PROJECT: City of Ferndale – Well Water Supply Project
Schedule B (Water Main)

ADDENDUM 1

**WELL WATER SUPPLY PROJECT,
SCHEDULE B (WATER MAIN)**

ADDENDUM NO. 1
To the Contract Provisions for
City of Ferndale, Washington

DATE
5/5/11
SHEET
9 of 33

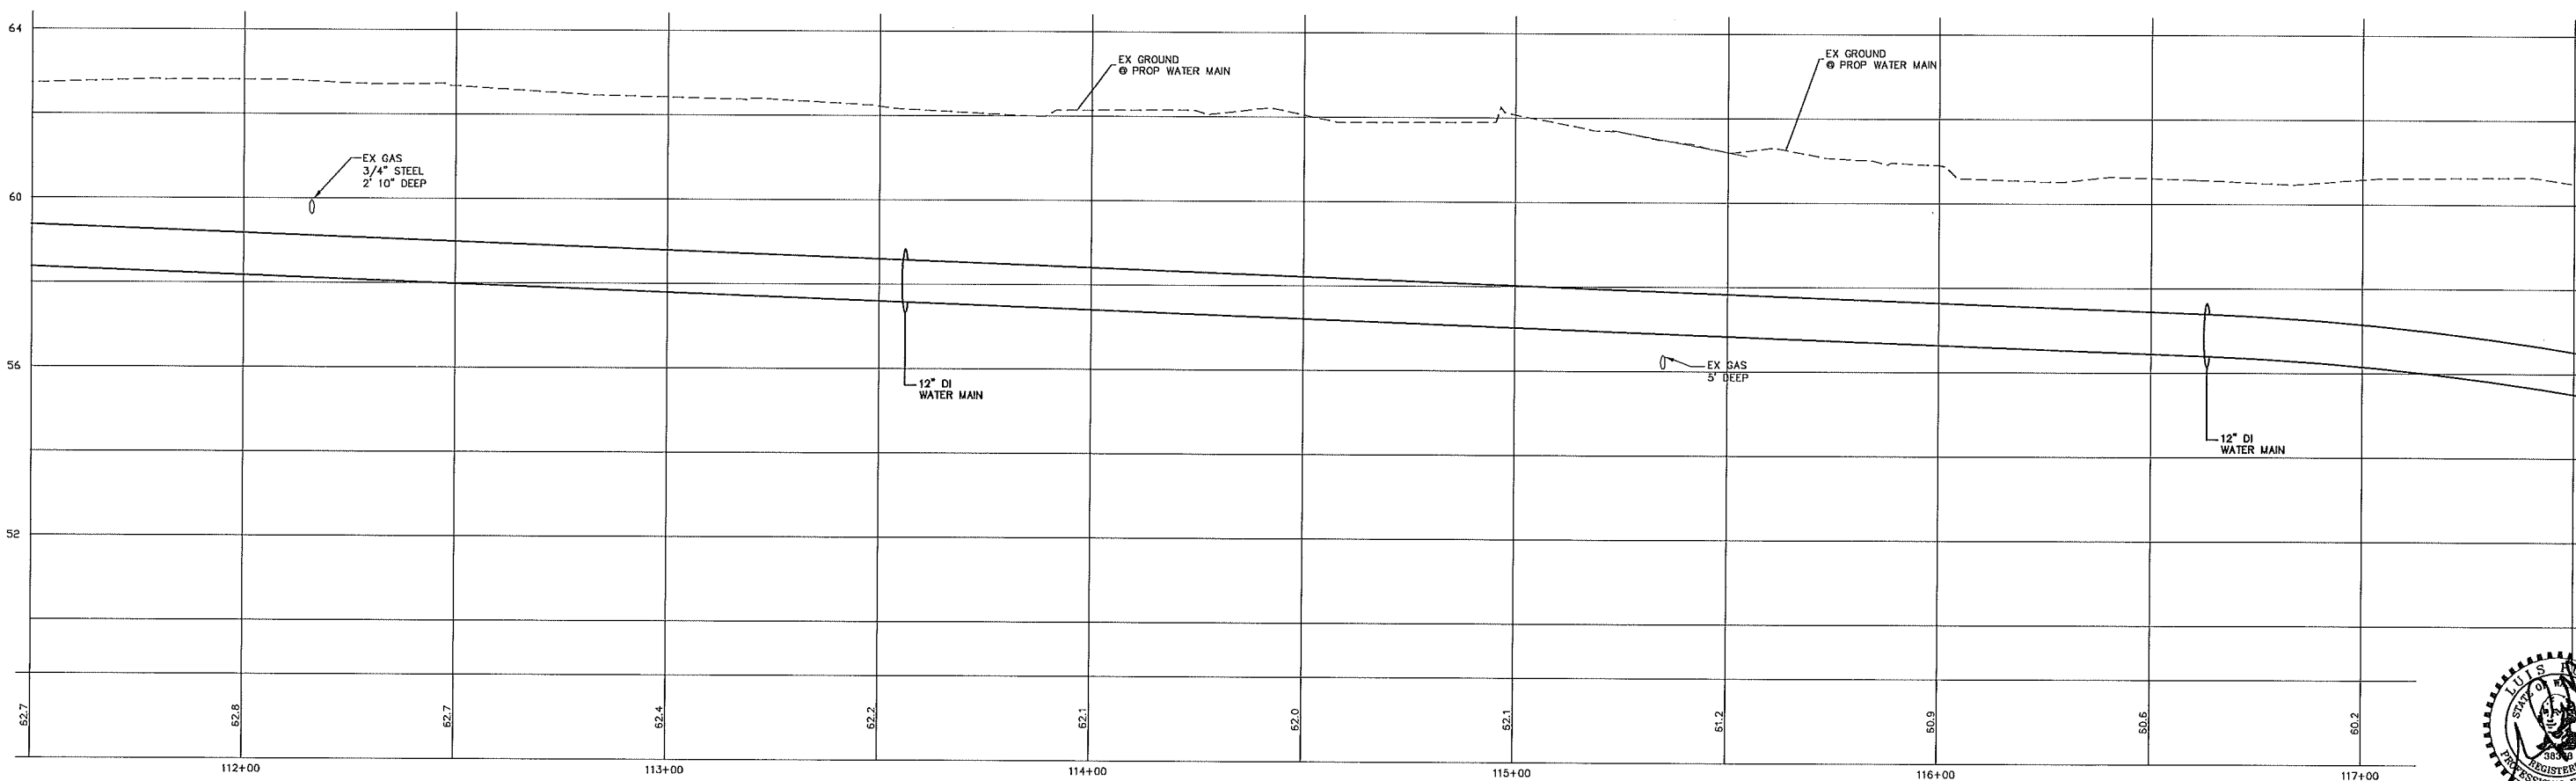
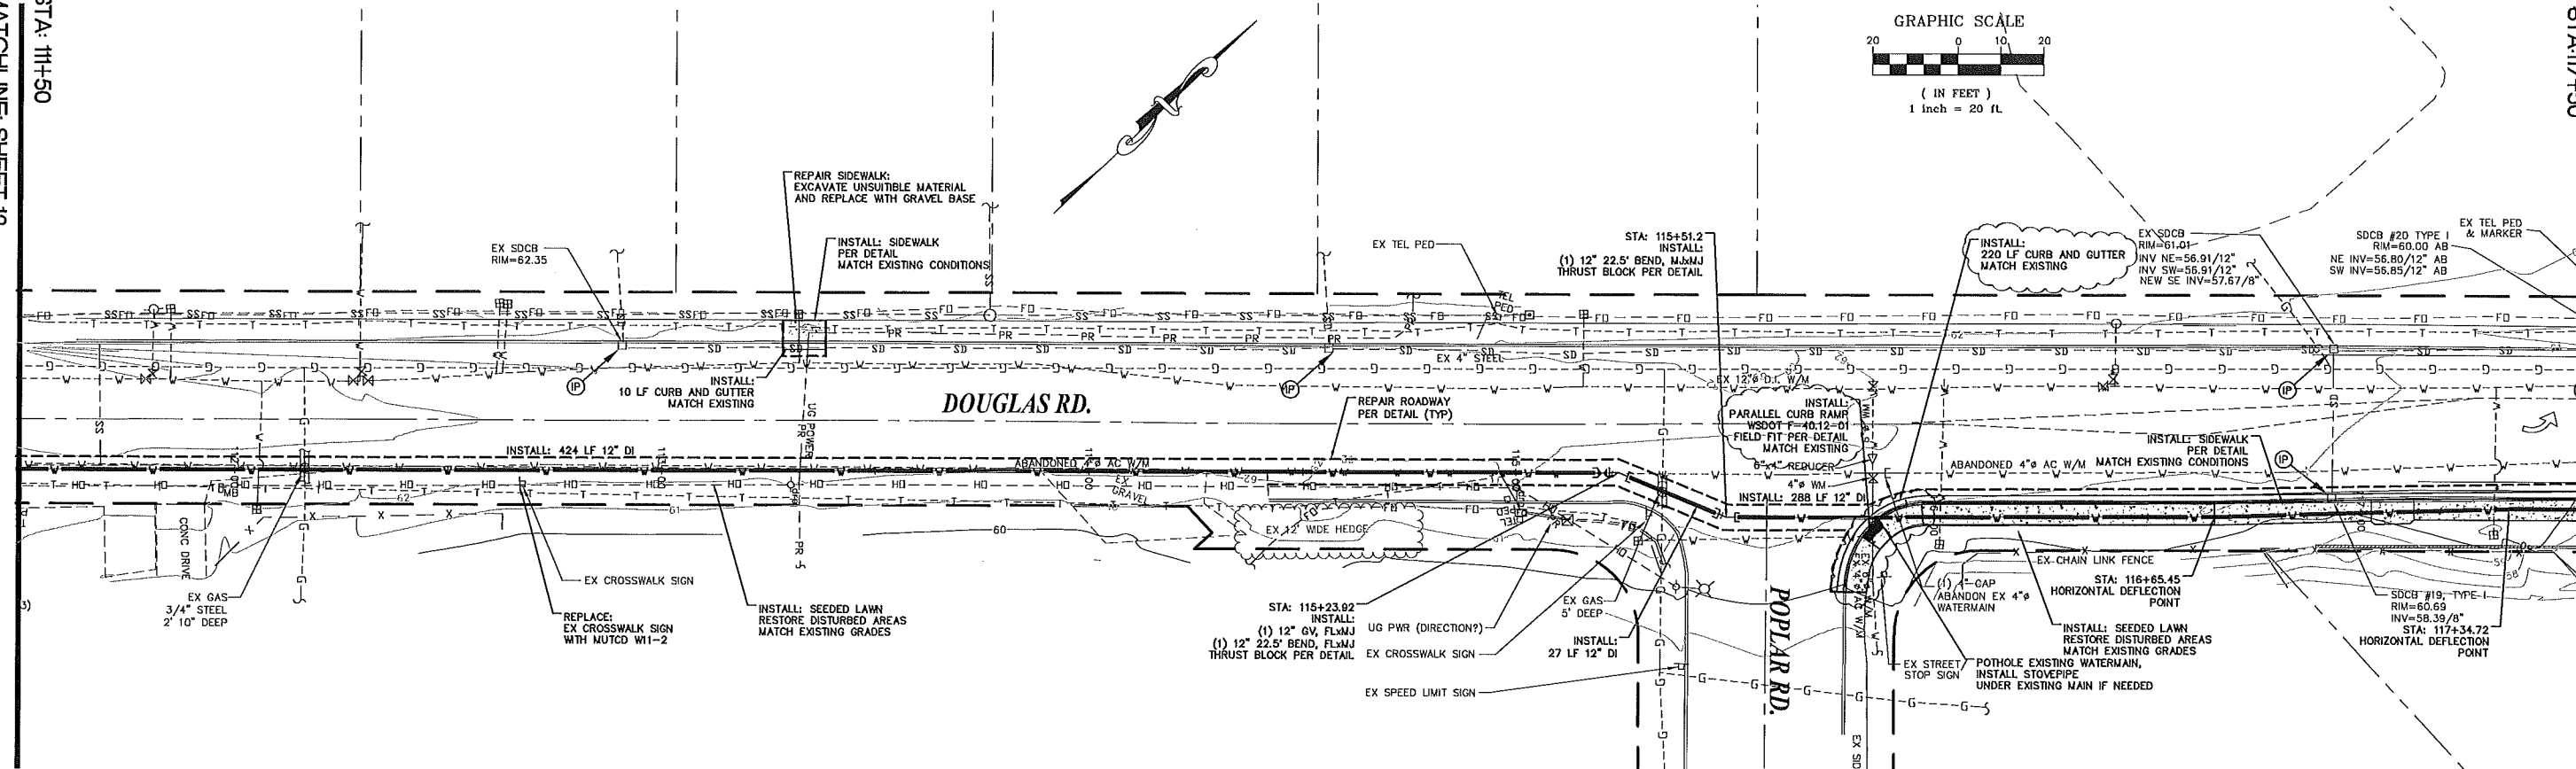
The attached Plan Sheets 8 and 9 shall replace the Plan Sheets 8 and 9 dated 4-20-10. The area of grub and remove rocks and asphalt is deleted as this work is deleted from the contract.

DATE
5/5/11
 SHEET
17 of 33

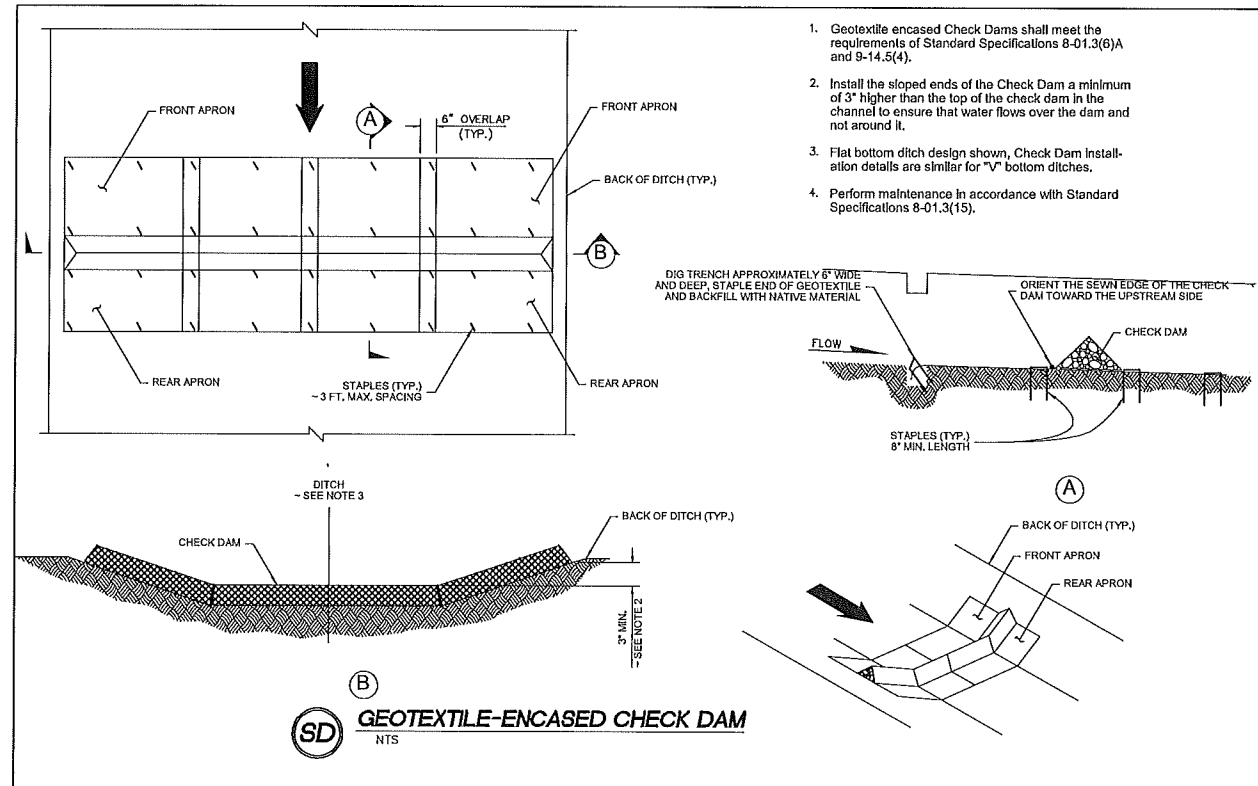
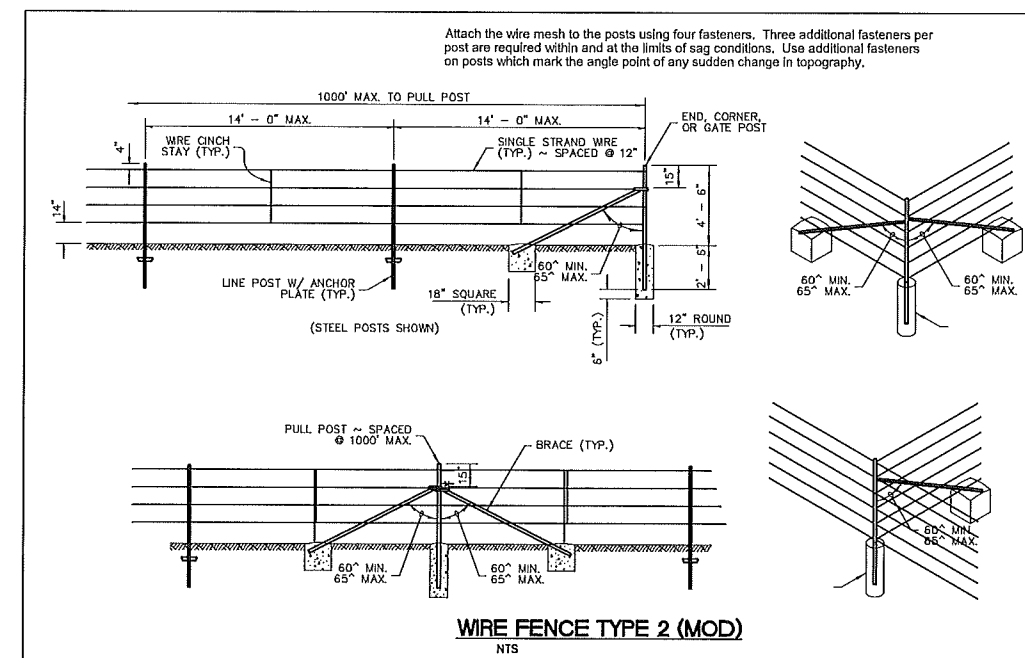
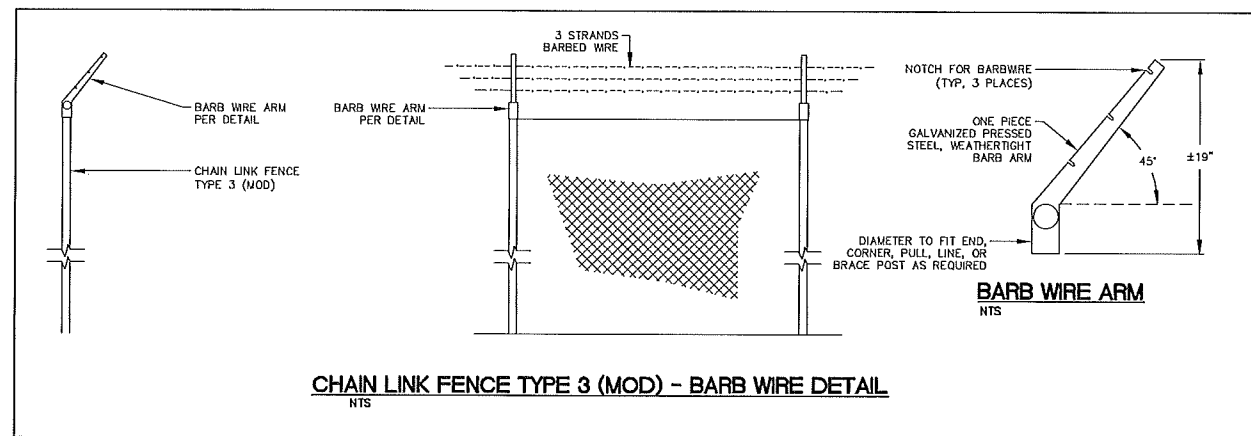
The attached Plan Sheet 17 shall replace the Plan Sheet 17 dated 4-20-10. Water main layout is revised and callouts are added.

JOB# / DWG 10020	DET.1ADD	DATE 5/5/11
SCALE H:N/A V:N/A	SHEET 30 of 33

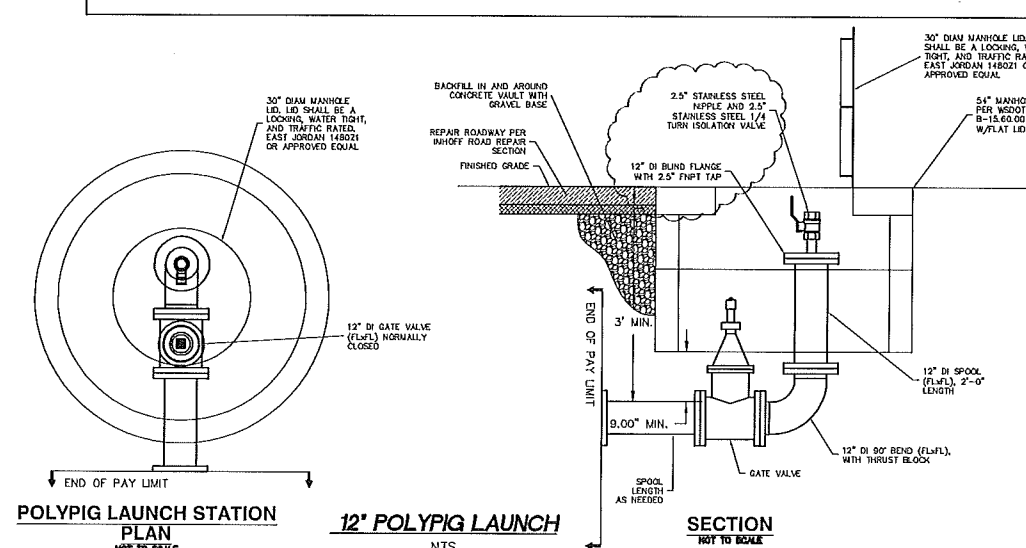
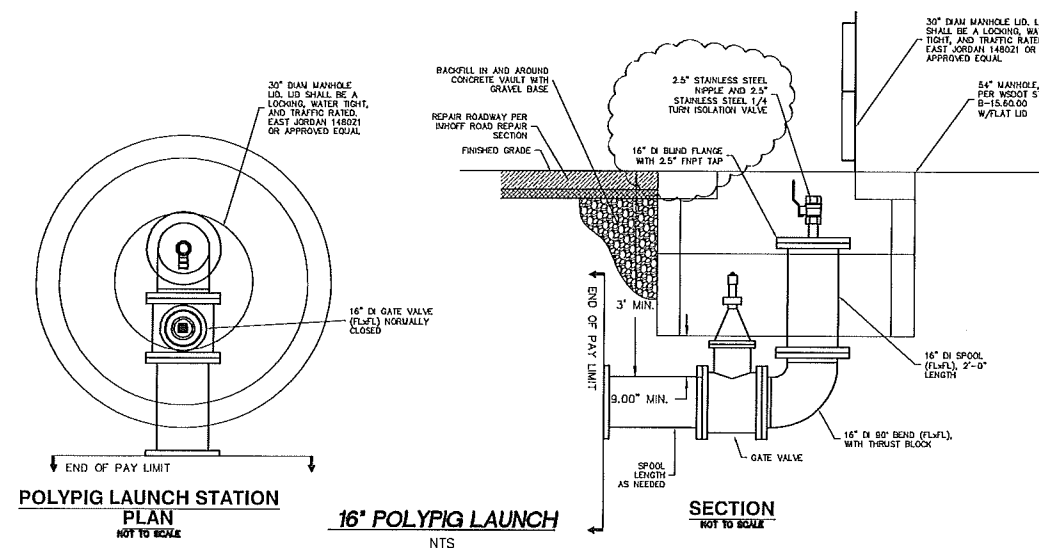
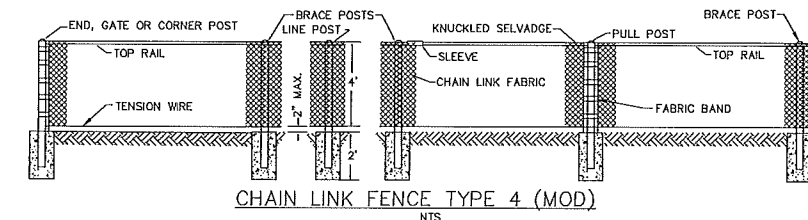
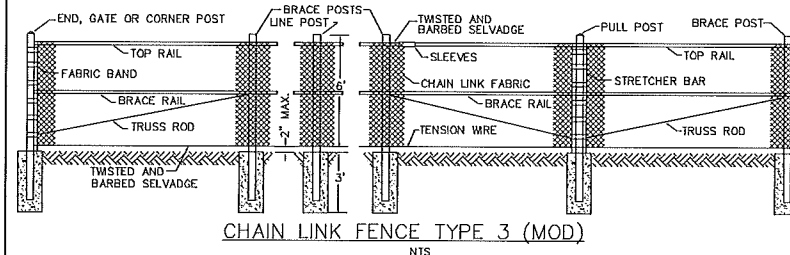
The attached Plan Sheet 30 shall replace the Plan Sheet 30 dated 4-20-10. Polypig launch callouts are revised.

JOB# / DWG	10020	DET.1ADD	DATE	5/5/11
SCALE	H:N/A	V:N/A	SHEET	32 of 33

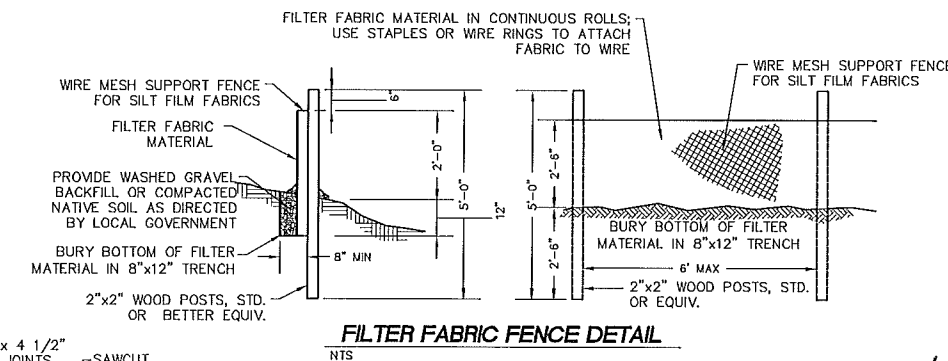
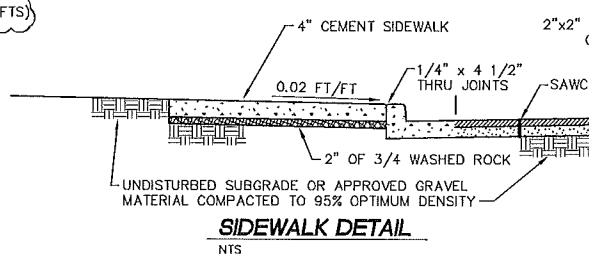
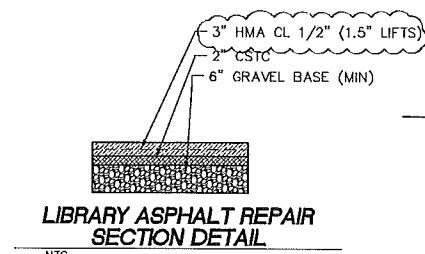
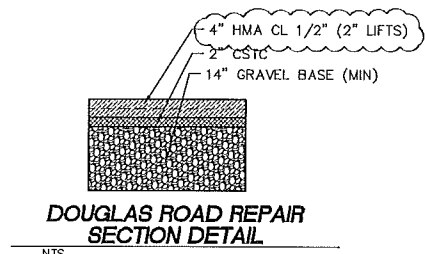
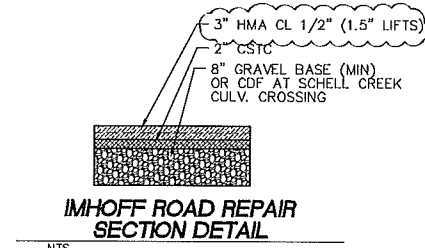
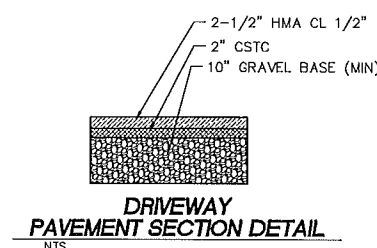
The attached Plan Sheet 32 shall replace the Plan Sheet 32 dated 4-20-10. Typical section stationing and details and culvert crossing detail are revised.
